# STAFF REPORT

**Meeting:** July 16, 2015

**Case:** RCC15-17

**Case:** RCC15-21

Proposed Sign superimposed onto Building

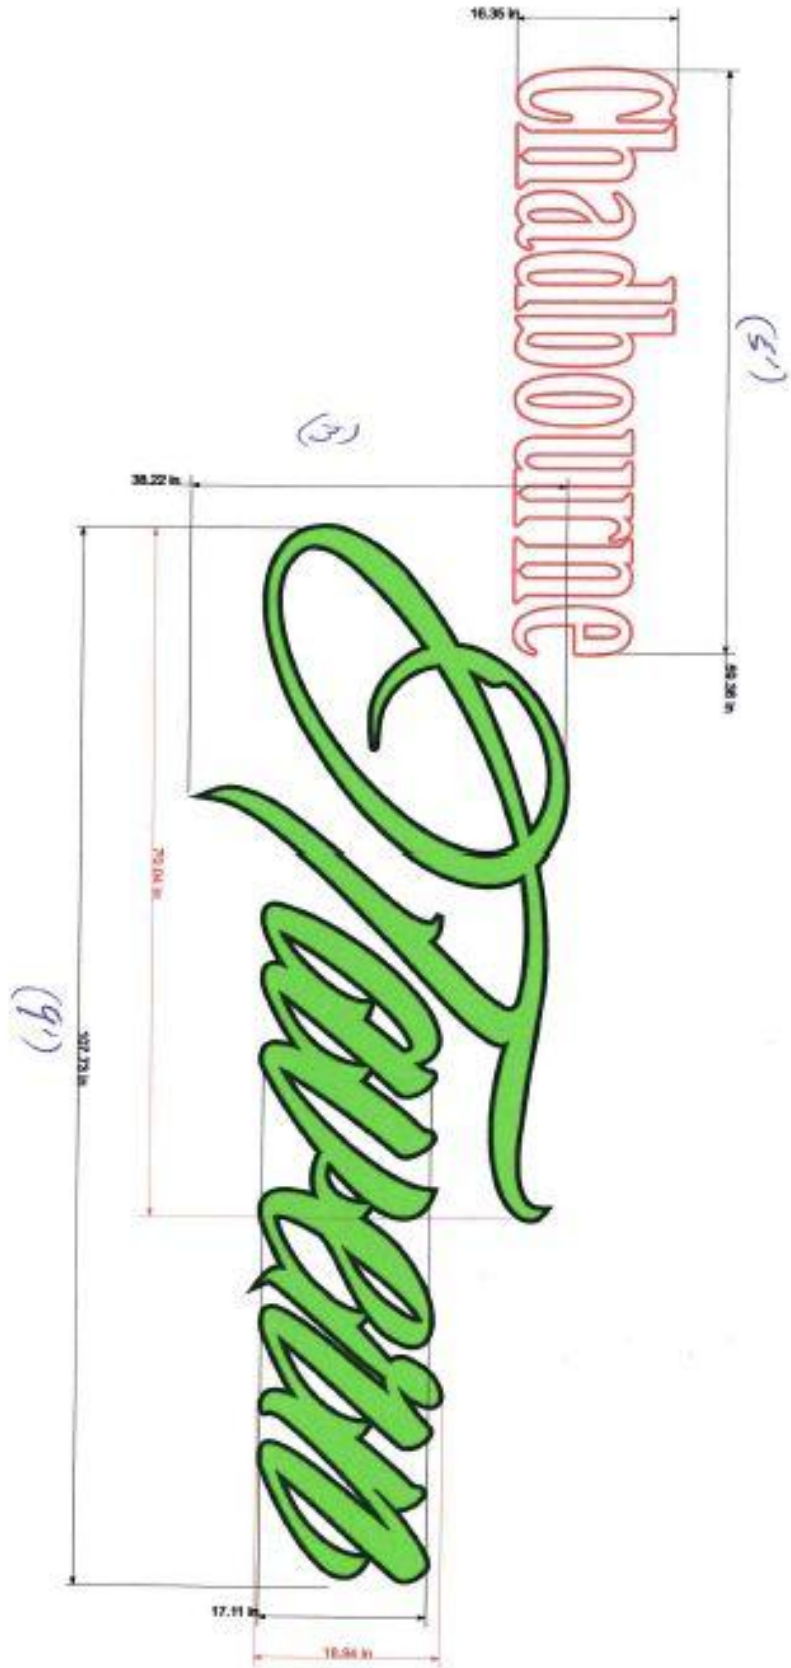
The proposed sign will be located 23 feet above grade on the second floor of the building. The sign will be constructed of translucent plexiglass with LED channel lighting inside. The word “Chadbourne” will be white with a red outline, and the word “Tavern” will be green with a black outline.

As indicated, 12.604(b)(2)(B) of the Sign Ordinance allows a sign to project into the public right-of-way providing it has a vertical clearance of 9 feet, and provided the leading edge maintains at least 18 inches (1.5 feet) from the curb line or street edge. The vertical clearance is over 23 feet from grade and the sidewalk is 14'-2" wide. Therefore, an Encroachment Approval will not be required from City Council for the sign.

Staff believes the proposed sign maintains the traditional fonts, styles and colors of those found in the River Corridor, and the sign would be incorporated into the existing building which also has a historical look. The

calligraphic fonts and the light green color of “Tavern” matches Fuentes Café Downtown, located just north of the subject property. The fonts are also similar to other buildings along South Chadbourne Street also, including Pink Piano at 113 South Chadbourne Street, Tejano Country (204), Chester Dorner Jewelers (219),and Lucky You! (227).

The proposed sign will be lit with LED channel letters, which would allow light spill to be controlled. Other buildings on South Chadbourne Street in the River Corridor also use LED lighting including the hanging signs on Griners and Stango’s Coffee Shop, as well as the wall sign on Fuentes Café Downtown. Staff believes the proposed sign would be consistent with the other signs in the area, and the LED lighting will not result in glare or light spill.

- 1. There shall be no glare of spillover illumination onto adjacent properties.**
- 2. The applicant shall obtain a Sign Permit from the Permits Division.**

# Building Elevations

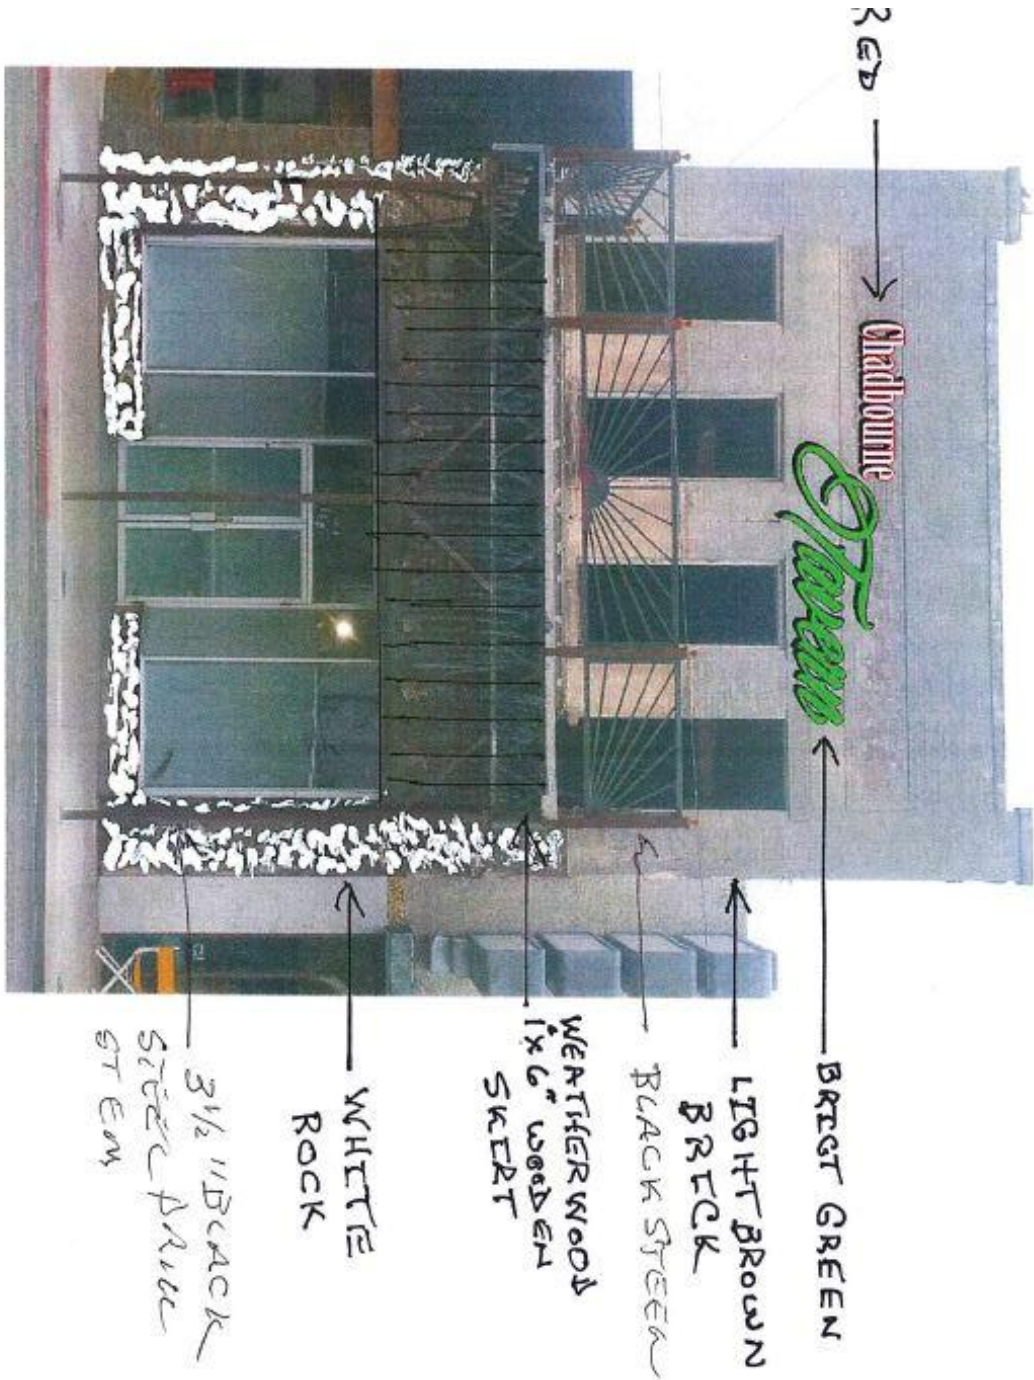
The canopy is 20-feet wide, with a vertical clearance of 13.5 feet from the sidewalk, at grade, to the horizontal frame. The wood skirt paneling under the canopy will be 10.5 feet from grade, but will not obstruct access underneath as it will be mounted to the front of the canopy only. As indicated previously, South Chadbourne Street meets the minimum right-of-way and paving widths per the City's approved Major Thoroughfare Plan. However, the canopy encroaches 12 feet into the 14'-2" wide sidewalk, and therefore, will require an Encroachment Approval from City Council. The applicant has already applied for this Encroachment Approval which is anticipated to be heard by City Council at its August 18<sup>th</sup> meeting. The new white limestone rock walls will be fixed atop the existing brown brick on the first floor where

the old marble tiling was removed. The limestone rock will cover the entire first floor to where the canopy floor begins, including the area not visible from the street behind the wood skirting. On the second floor, light tan walls will be repainted a darker color to provide contrast in building color, consistent with other buildings in the River Corridor.

A combination of the black steel canopy, natural wood finishing below, limestone rock walls, and natural brick on the second floor, provide pattern variation in the building façade, consistent with the Architectural Detail policy above. Limestone rock and wood skirting below the canopy uses natural elements that are reflective of the historical character of the area along South Chadbourne Street, as explained in the general design guidelines above. The new black steel columns, posts, and railings on the canopy provide some modern elements to the building, consistent with other buildings in the area, but still maintain the building's historical character.

Section 3202.3.1 of the International Building Code (IBC) requires a vertical clearance of 15 feet for awnings and canopies where they extend more than 2/3 into the sidewalk, when measured from the building. As mentioned previously, the canopy projects 12 feet into the sidewalk which is 14'-2" wide (14.16 feet), which is more than 2/3 of the way over. However, the IBC in Section 104.10 also states that the Building Official may waive this requirement in instances where he finds that the strict letter of this code is impractical and the modification is in compliance with the intent of the code and further, that the modification does not lessen health, accessibility, life and fire safety, or structural requirements. This balcony is intended to be used by second floor inhabitants and as such the elevation is limited. The Fire Marshal was consulted to ensure that the intent of fire fighting access will not be hindered by the proposed height of the balcony. As indicated above, the Permits Division had previously issued a building permit for the canopy, and the Building Official has confirmed that the canopy does meet the intent of the code and therefore, meets the IBC requirement.

1. **The applicant shall obtain an approval from City Council for any required grease trap, building, and portion of the canopies, structures, or the like which may project onto a public right-of-way.**

## Material Samples

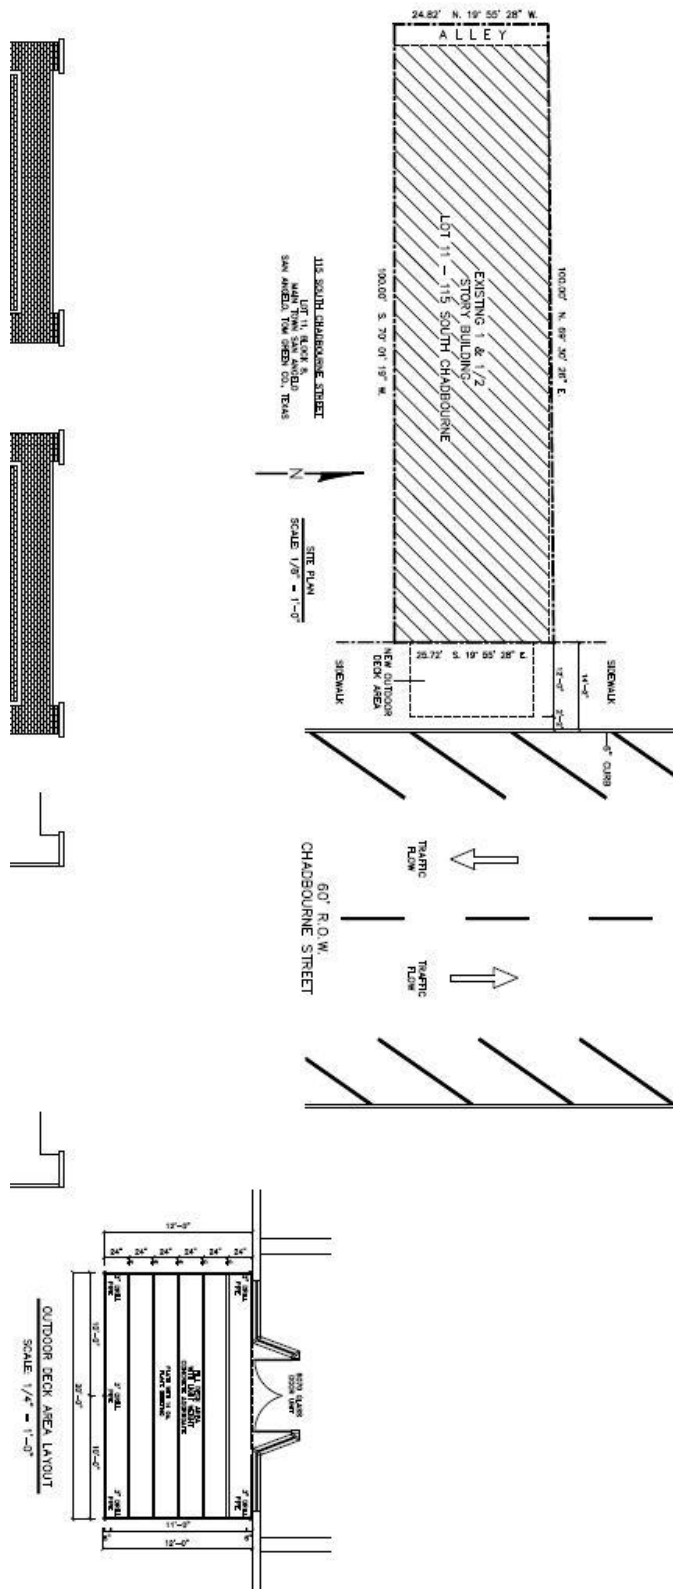
As indicated, several of the storefronts along South Chadbourne Street already have a light stone finish, similar to what is being proposed on the subject building. The white limestone rock is also a quality material – matching the historical color of the area, while upgrading to a more varied design in the stone cut. The variation in the texture and design would reduce the appearance of a blank wall and visually blend with the historical character of this portion of the River Corridor. The black steel canopy and natural wood skirting would be consistent with the new façade improvements immediately south at the Zada Décor Building (RCC14-38) which were previously approved, as well as the canopy of Stango's Coffee. Repainting the second floor brick to a “Trusty Tan” would provide the necessary contrast, consistent with the other buildings on South Chadbourne Street where the first and second floors use contrasting colors and building elements to provide variation in the streetscape. The applicant has submitted a color sample of the Trusty Tan color proposed for the second floor brick. This color is very close to the “Sycamore Tan” color, one of the approved colors of the Historical Color Palette of the City of San Angelo, which applies to exterior remodeling in the Central Business District for buildings of this time period.

# Building Renderings and Details

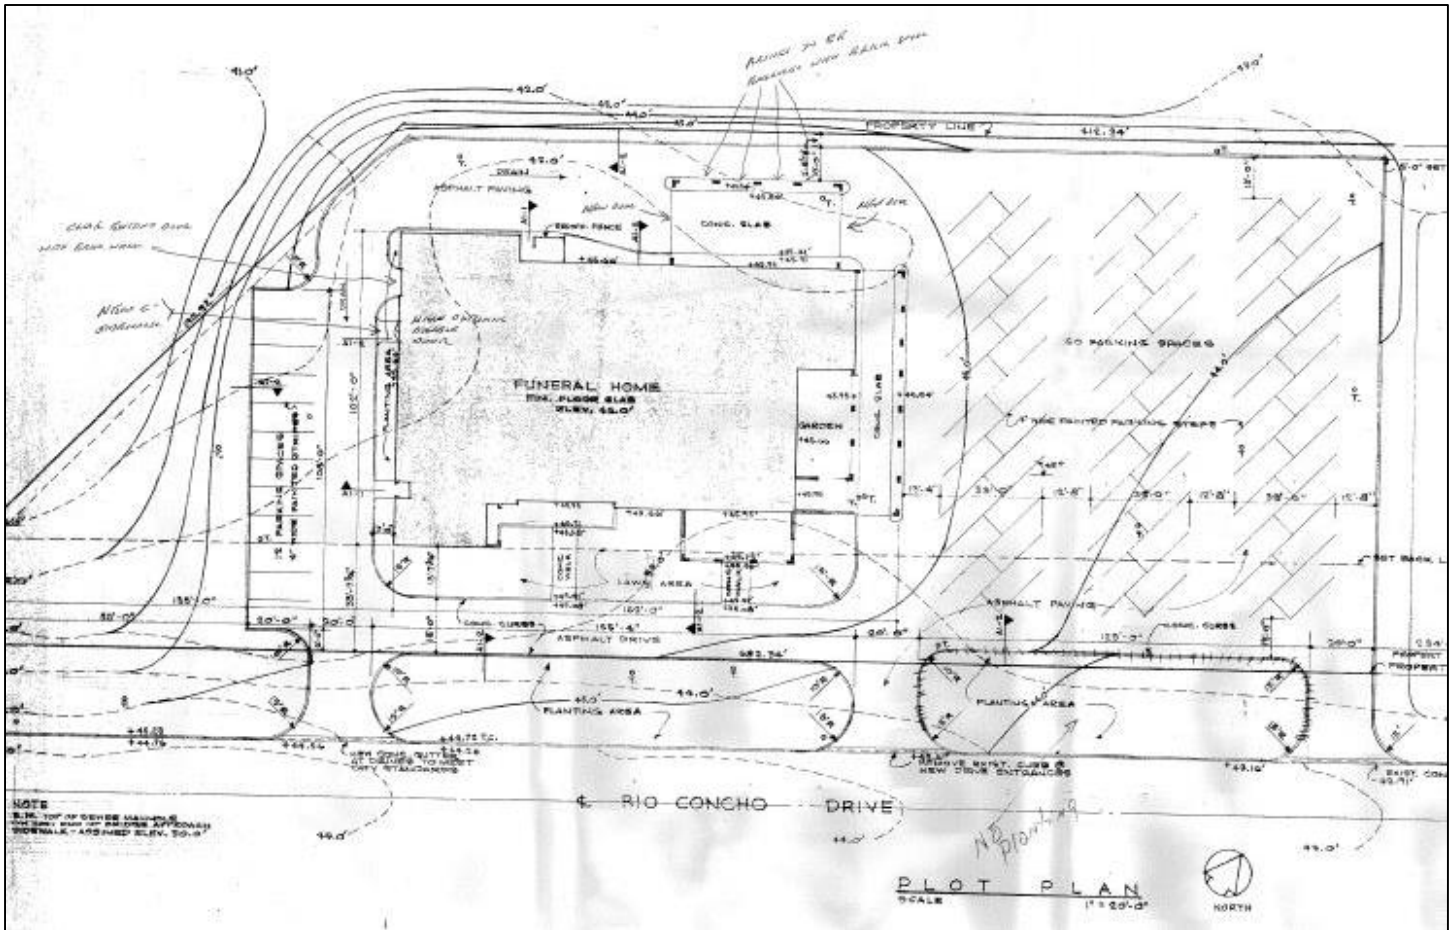
Concerns and the River Front” section also states that buildings should be designed with architectural elements and patterns on the elevations facing the river bank, even though this may be the rear elevation. The applicant is seeking to construct the proposed walls with bricks of a lighter color using a brick pattern that includes small-scale design elements. The lighter color of the proposed brick walls and smaller design elements will provide variety to the overall design. In addition, they will avoid the effect of blank walls that do not address the pedestrian nature of the adjacent park area. These bricks are comprised of durable materials that typically do not require a high degree of maintenance and therefore appear to be appropriate for the proposed walls. In addition, brick has been used in all the existing building facades and seem to still be in very good condition.

Subsection III of the “Commercial Use Outside of the Historic City Center” section states that light to medium colors with low reflectivity are preferred as the background building color and that warm, subdued hues of natural, earth colors are also encouraged. Subsection I of the “Other Environmental Concerns and the River Front” section further states that the character of landscaping should be formal for areas closer to buildings and developed areas. The applicant has provided a sample of the type and color of brick to be used. The proposed new brick wall will match the existing brick on the building. These bricks conform to ASTM C652 (from the American Society for Testing and Materials) which controls the brick’s ability to resist damage from water as a result of cracking or freezing. Furthermore, the color chosen is a matte, non-reflective tone of brown consistent with the building materials used on many other structures in the area. To this end, the proposed brick wall therefore

- 1. The proposed walls to be built within the existing archways on the north façade shall be constructed of brick that is of a lighter color than that found in the existing archway and shall have a brick pattern that includes small-scale design elements.**

2. On the west façade, new shrubs that mimic the existing planting pattern shall be placed in the area where the existing door will be removed. These shrubs shall comply with Xeriscape landscaping principles for the San Angelo area and shall be at least 18 inches in height at the time of planting.
3. The final design of the proposed remodeling shall be subject to review and approval by the Planning & Development Department Director, or his/her designee, and shall be consistent with this Design & Historic Review Commission River Corridor approval.

## Proposed Garage Doors

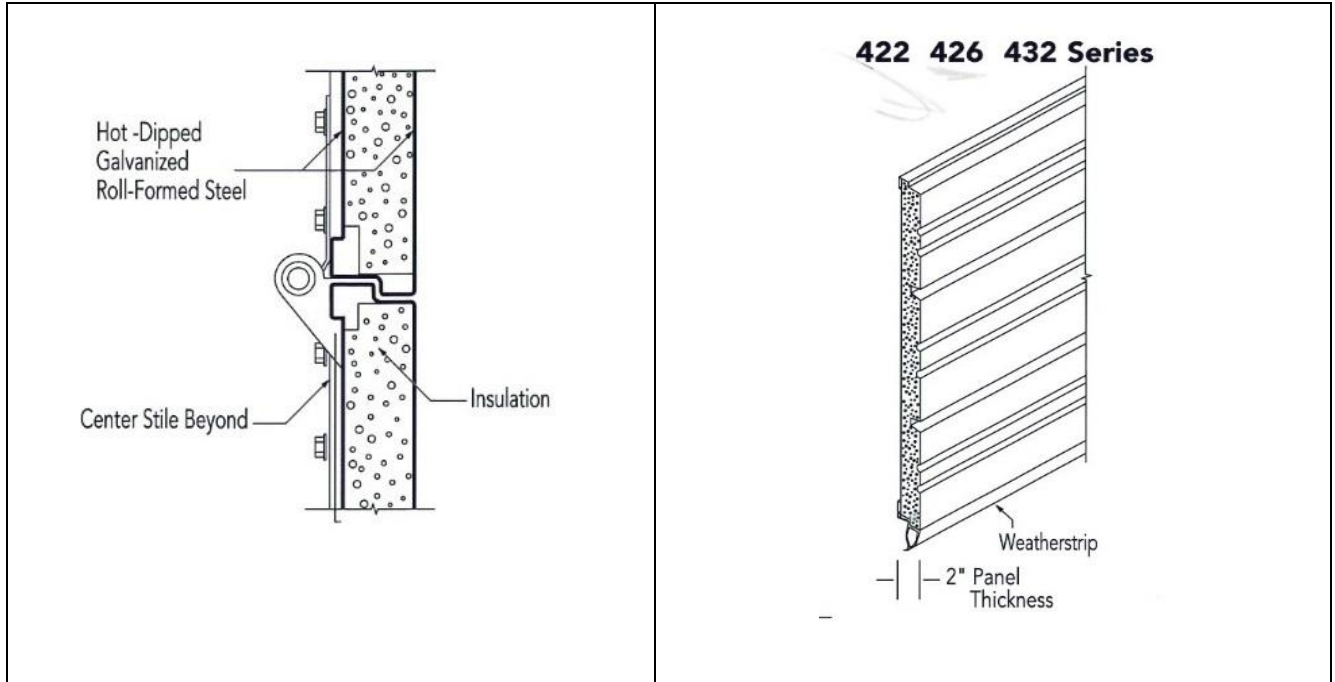
Subsection III of the “Commercial Use Outside of the Historic City Center” section states that high-quality, durable materials are encouraged. The proposed garage doors have a 2-inch panel thickness with insulation material and will be finished in a factory-baked brown color that provides high durability. These type of garage doors are designed for heavy duty applications, include 16 gauge steel intermediate and end stiles, ribbed steel exteriors, and a 26-gauge steel back cover. They will have polystyrene insulation with an R-Value of 7.35. An “R-Value” refers to the capacity of an insulating material to resist heat flow. The higher the R-Value, the greater the insulating power. Hinges and fixtures will be galvanized steel and a bottom weather strip of flexible PVC will be held in place by a retainer that provides additional reinforcement. The proposed garage doors therefore appear to be of high-quality, made with durable materials that seem consistent with the recommendations of the River Corridor Master Plan.
